TOWN OF BAY HARBOR ISLANDS
DEVELOPMENT & REVIEW COMMITTEE MEETING
THURSDAY, APRIL 13, 2023

AGENDA ITEM REPORT
April 13, 2023

TOWN OF BAY HARBOR ISLANDS COMMUNITY DEVELOPMENT MEMORANDUM

Subject: Site Development Plan Application – 2023 Revisions (#3 DRC Review)
1177 Kane Concourse Mixed Use Development
Decrease DU from 90 to 54 / 98,046 Sq. Ft. Office / 15,525 Sq. Ft. Comm.
Bay Harbor Islands Acct. No. SPR23-000005
MMPA Acct. No. 01-0702-1063C

1 FLOOR PLAN - LEVEL 9 ROOF DECK

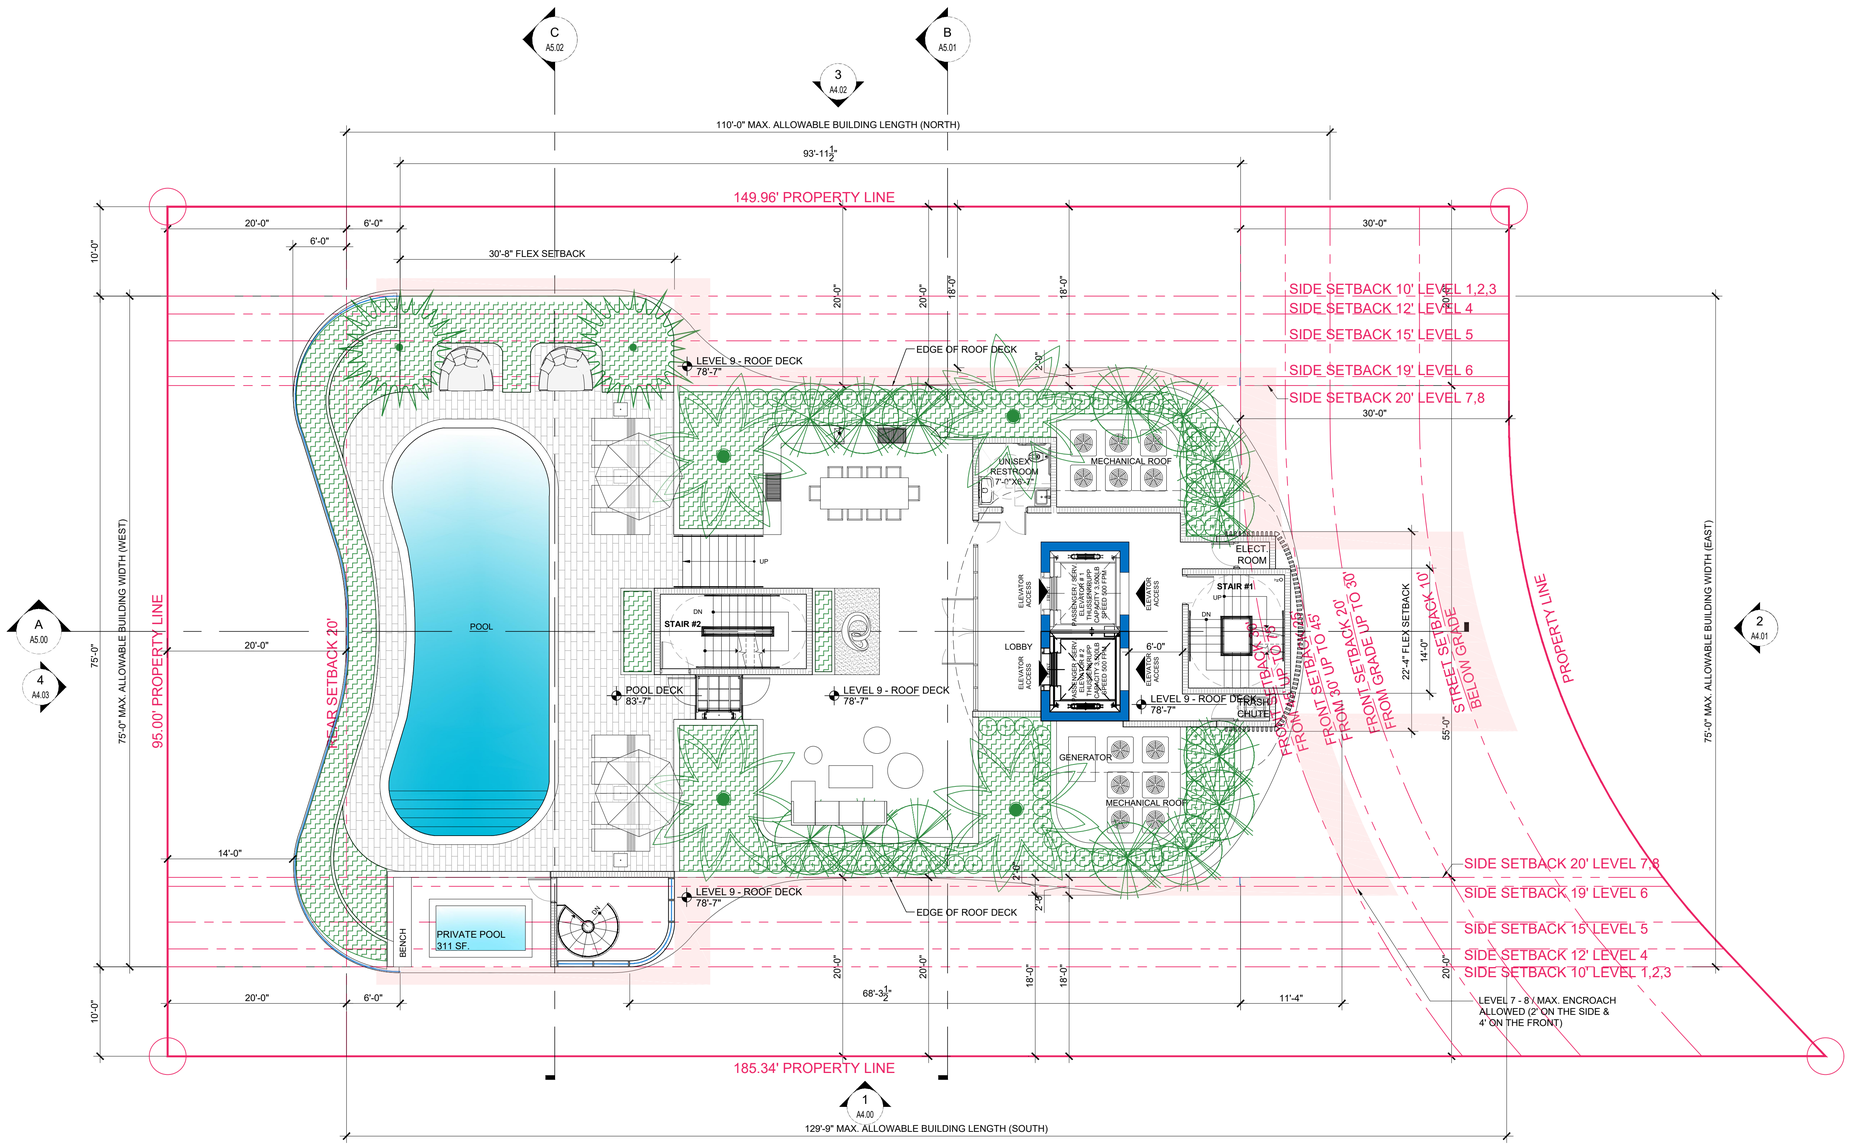
3) **Previous Comment from March 6th, 2023 Not Addressed** - On Sheet A3.08 and A3.09 the roof deck may not extend into any required setback area – it appears to do so – creating a "hat" for the building. See Sec. 23-12(15) for allowable setback encroachment features. Specified architectural features can encroach up to 4' F&R and 2' Sides. The Town's urban design goal is to limit the height appearance of buildings by limiting rooftop structures and requiring most features to not encroach past the edge of the main building façade and set back onto the roof. The architectural features now shown (remove the words "roof deck" and add the words "eyebrow / fenestration / architectural band / etc." on all sheets) extending from the main roof into setback areas appear to have been modified to meet the allowable yard encroachments - except for the rear setback – while 4' is allowed the plans still show a 6' encroachment. A "balcony" is not allowed for the roof either – a balcony is defined as an attachment to the exterior facades of buildings with access thereto from the dwelling units. Revise the plans to comply with Code limitations.

8) On Sheet A3.08 and A3.09 the roof deck may not extend into any required setback area - it appears to do so - creating a "hat" for the building. See Sec. 23-12(15) for allowable setback encroachment features. Specified architectural features can encroach up to 4' F&R and 2' Sides. The Town's urban design goal is to limit the height appearance of buildings by limiting rooftop structures and requiring most features to not encroach past the edge of the main building fa9ade and set back onto th!3 roof. Again, a portion of the enclosed elevator vestibule facing EBHD appears to encroach into the minimum front yard setback (30'). Remove these areas.	Refer to Sheets A3.08 and A3.09. The roof deck has been revised and is no longer extending into the setback area.

Drawing: Landscape Plan
Date: 01.15.2023
Scale: 1/8"=1' - 0"
Drawn by: JRP
Sheet No.:
L-1

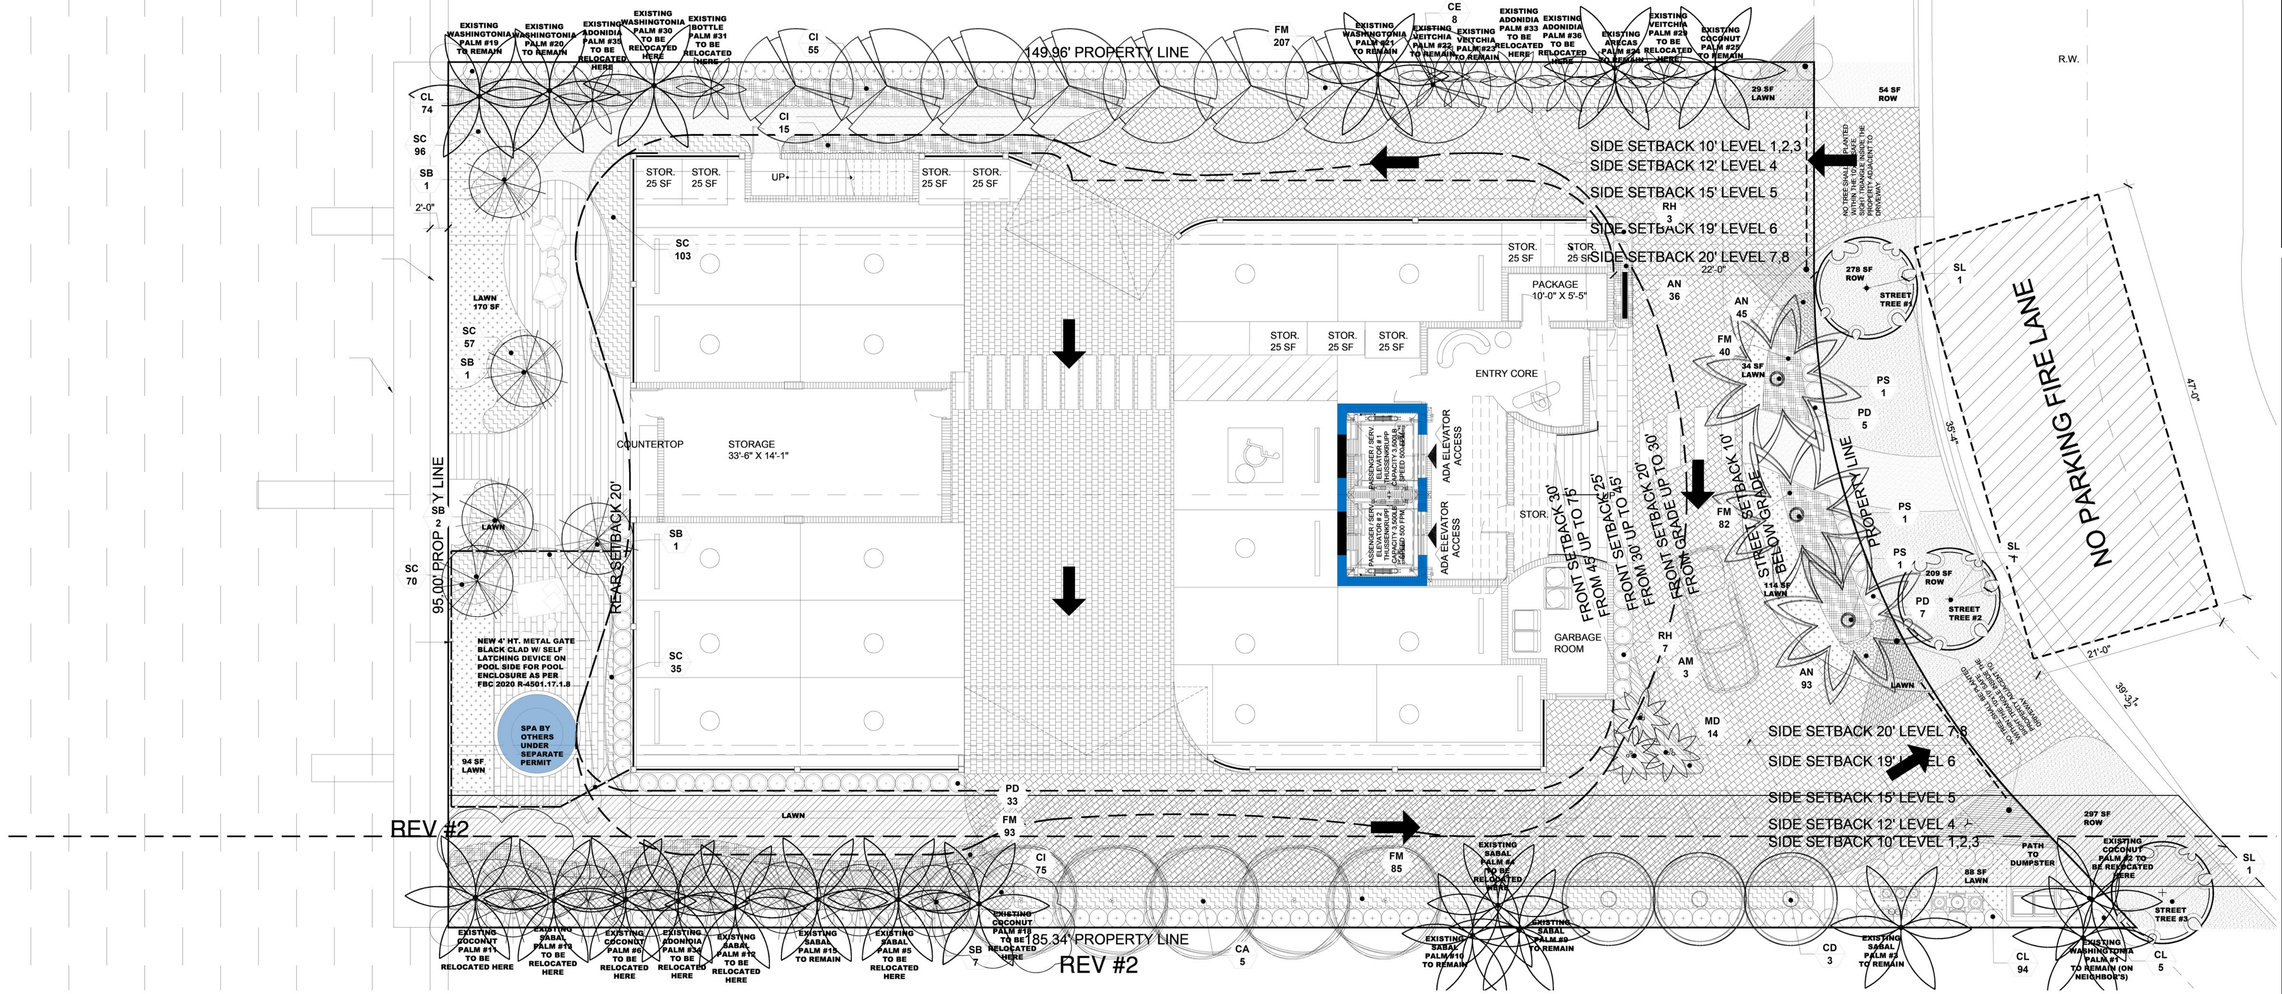
2 c) Please dimension the proposed sidewalk connecting to E. Bay Harbor Drive from the building and the sidewalk from the pool deck to the seawall / dock. The plans scale to 4' in width-a maximum of 5' is allowed per Sec. 23-12(15).	Refer to Sheet A2.00. Sidewalks are to be 4'-1" in width.
	2 d) Please label the type of material for the driveway and sidewalk.	Refer to Sheet A2.00. Concrete pavers on sand are being proposed for the driveway and sidewalk.
CIVIL - OCEAN ENGINEER	3) Please provide a preliminary pavement marking and signage plan in the civil engineering set of plans.	Refer to Sheet C200.
LANDSCAPE - ECOPACHECO	4) On Landscape Plan Sheet L-1 under plant schedule please remove "gallons" from the description from the shrub section. Both the Miami-Dade Landscape Code (Ch. 18A) and Town Supplemental Landscape Code specify trees/ shrubs by size/ spacing - not gallons. One could have a 15-gallon container with a 2-foot tall plant. Also, some of the shrubs are specified at 18" at time of planting- the Town Code minimum is 24" hgt. x 24" on center. Revise the plans.	Refer to Sheet L-1 and L-2. Plant schedule has been revised.
